Mission Viejo Country Club

10/25/06 BdMtg Item 10
 303(d) List
 Deadline: 10/20/06 5pm

RE: Comment Letter – 2006 Federal CWA Section 303(d) List

Figure
1

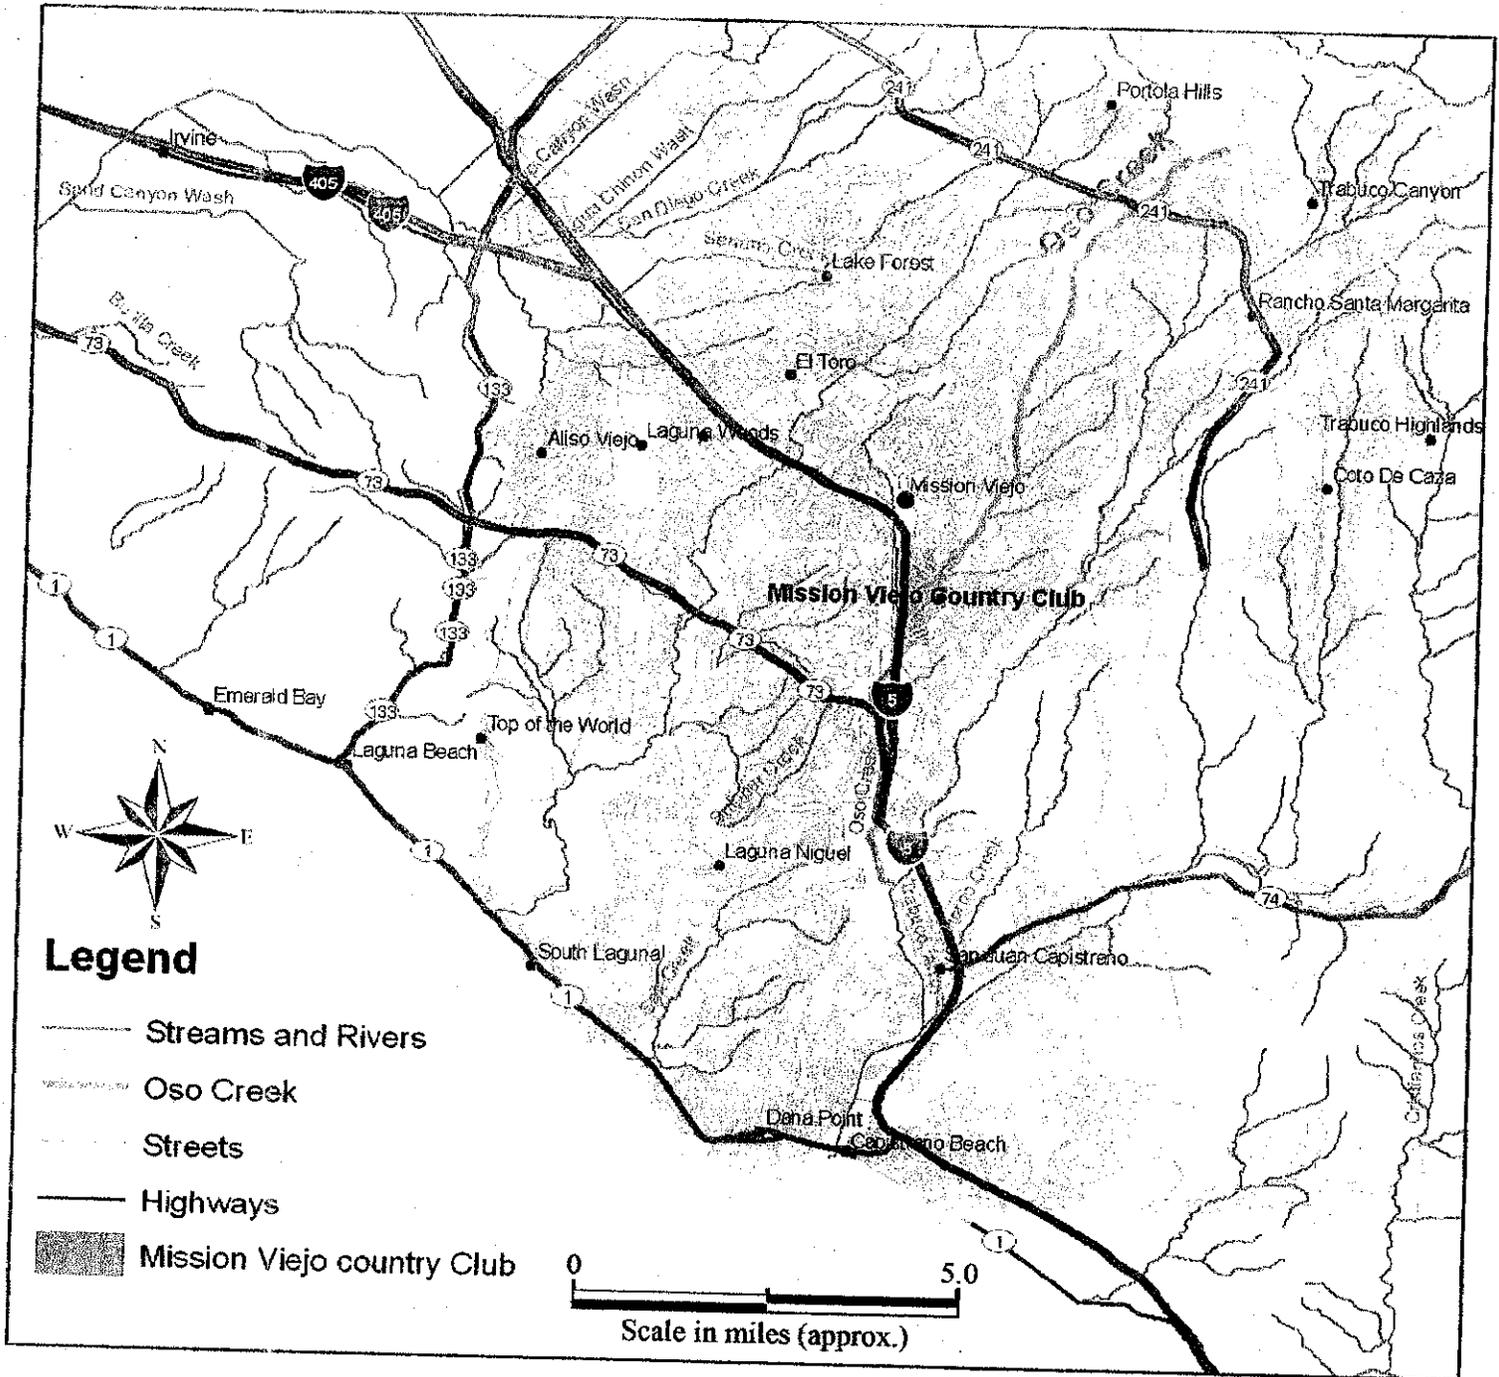
First, we acknowledge that the water quality in 4-mile long Oso Creek is impaired. Oso Creek collects urban runoff from over 8 square miles within the City of Mission Viejo. According to the September 2006 Fact Sheets Supporting Revision to the 303(d) list, 13 quarterly samples were collected from 1998-2001 by the Santa Margarita Water District (SMWD) and showed total dissolved solids, chloride and sulfate exceeding water quality objectives. According to SMWD staff, these quarterly samples were collected at the Oso Barrier, located on the last ½ mile of the creek. The purpose of the barrier is to take urban runoff collected by Oso Creek, screen it, and pump it to a reservoir for later use as a reclaimed water source for irrigation. Oso Barrier is located within the boundaries of the Mission Viejo Country Club. Refer to Figure 1.

The proposed listing indicates that 1 mile of the creek is impaired, but the Fact Sheet offers no rationale for this distance. We question the accuracy of this 1 mile distance because only 1 sample site was used and sampling was done at the last ½ mile of an 8.5 mile long creek that collects urban runoff from over 10 square miles of densely populated area containing over 100 catchment basins. Accordingly, we recommend that the estimated size affected be changed to "unknown" until such time as data becomes available to more accurately characterize the length of impairment.

Further, the proposed listing states "Oso Creek (at Mission Viejo Golf Course)", suggesting that it is the golf course that is responsible for the listing. We disagree that the listing has anything to do with the golf course and instead is almost assuredly due to the urban runoff entering Oso Creek upstream of the Oso Barrier. Accordingly, we recommend that the name of the water quality limited segment be changed to "Oso Creek (at Oso Barrier)".
